DTNA Solutions > Service Solutions > Western Star
> SS 711-WST 2021 49X Aux E-vault Rattle in Day Cab

SS 711-WST 2021 49X Aux E-vault Rattle in Day Cab

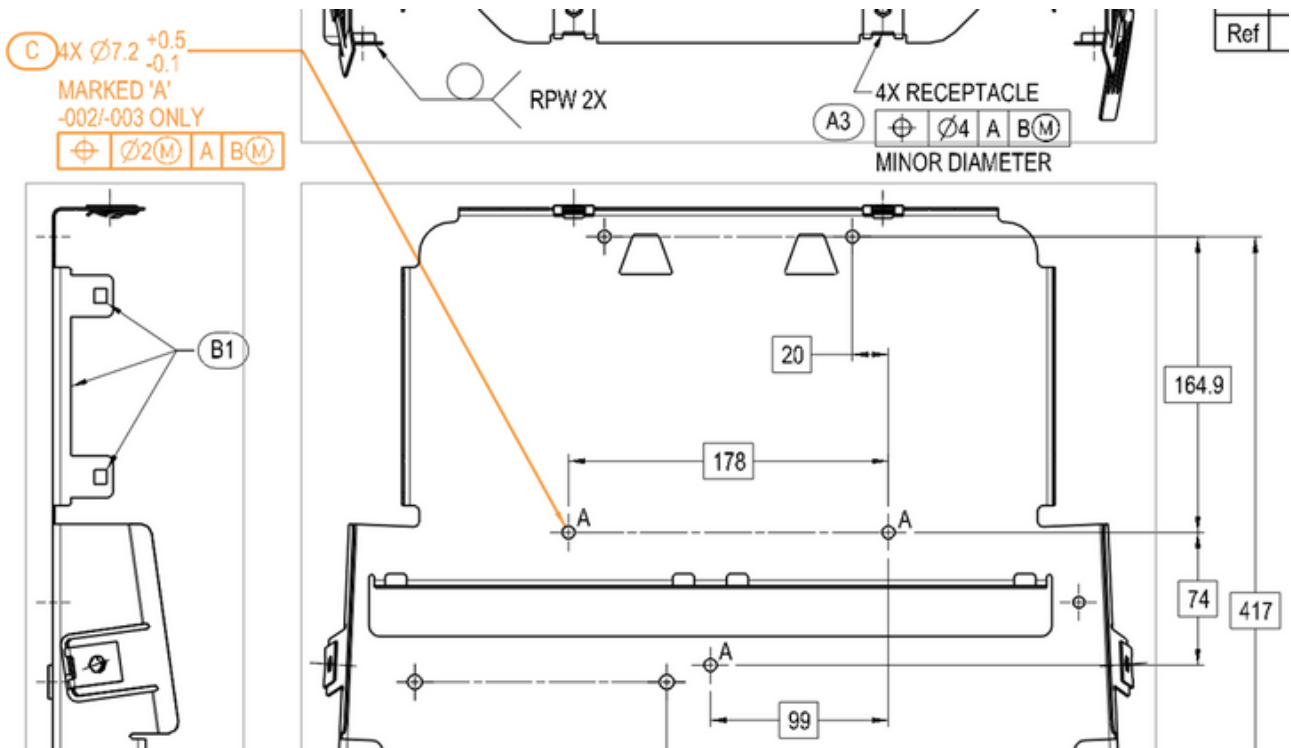
Rattle noise inside of cab coming from the e-vault location

Mounting bracket has low fore/aft stiffness

Drill quantity (3) 7.2mm dia hole 12mm deep through both mounting brackets while installed in vehicle per install locations below (additional 7.2mm hole shown below in upper rh corner of the drawing as reference point for dimensions) and add in quantity (3) each M6 bolt 000000 001476 & M6 23-12753-006 clinch nut.
